FINAL PLAT OF
COTTONWOOD GROVE SECOND ADDITION

Re: Final Plat S/D 86-92 - COTTONWOOD GROVE SECOND ADDITION

Final Plat
SUBDIVISION REPORT

S/D No.: 86-92 Name: COTTONWOOD GROVE SECOND ADDITION

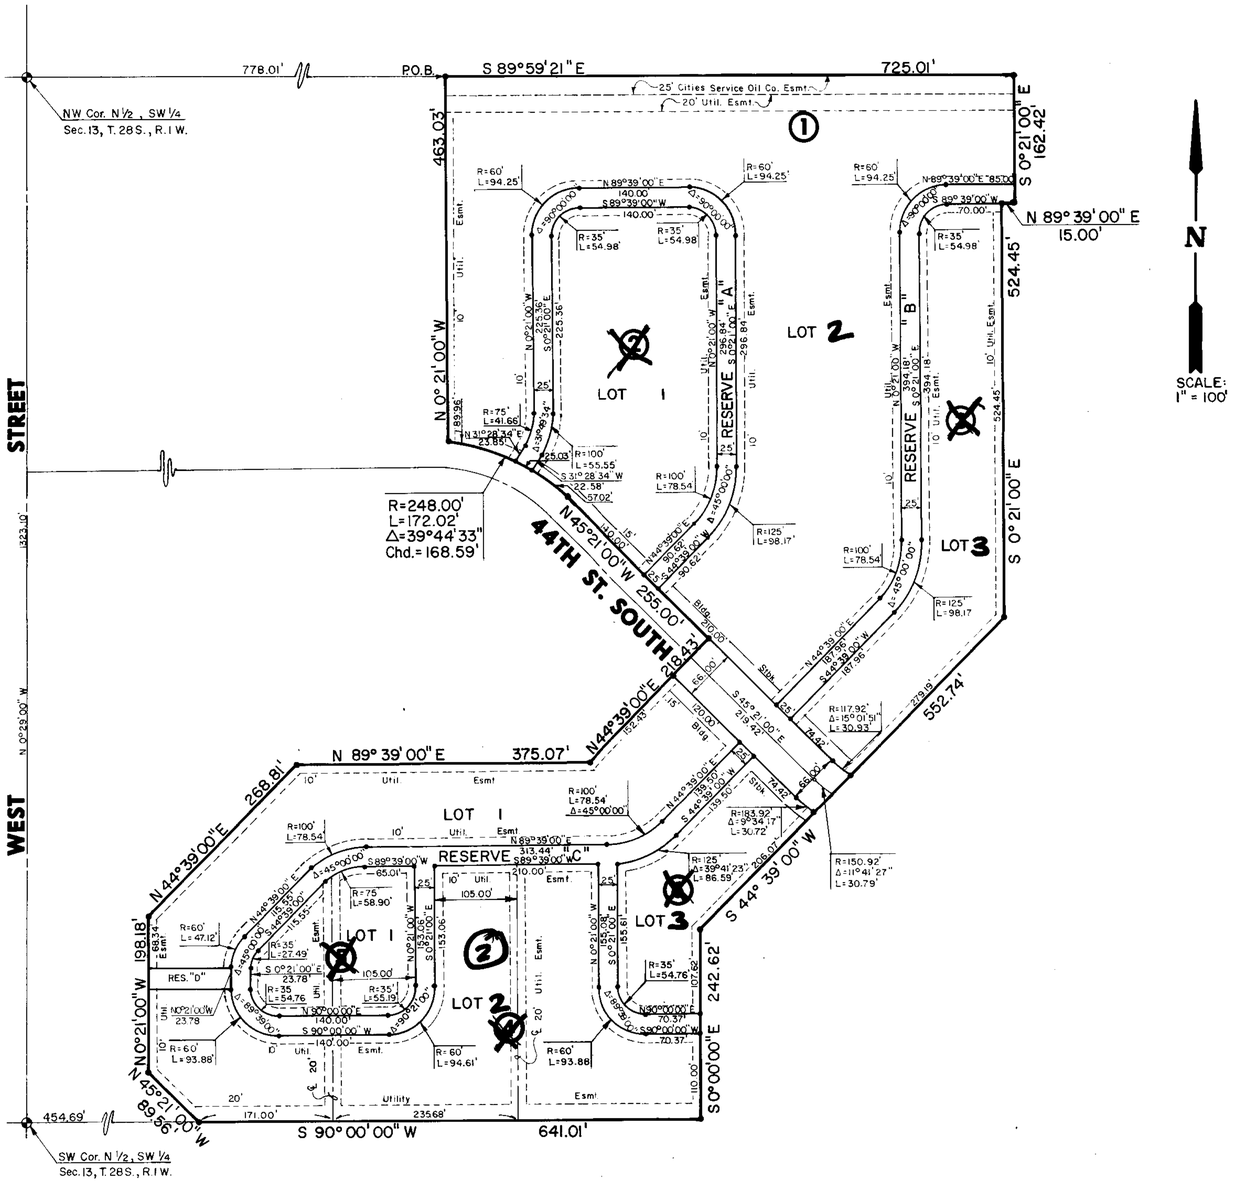
H. The final plat tracing shall indicate "complete access control" to 44th Street from this plat except at the location of the reserves. Appropriate wording shall be added to the plattor's text.

I. On the final plat tracing, only two blocks shall be labeled instead of six. Block 1 should be the area north of 44th Street and Block 2 should be the area south of 44th. This change will be consistent with how the first Cottonwood Grove Addition was platted.

J. On the final plat tracing, the plattor's text shall be amended to reference that Reserve A will be owned and maintained by the owners of Lots 1 and 2, Block 1. That Reserve B will be owned and maintained by the owners of Lots 2 and 3, Block 1. That Reserve C will be owned and maintained by the owners of Lots 1, 2 and 3, Block 2.

K. The final plat shall indicate the recording information for the 25-foot Cities Service Oil Company easement on this property.
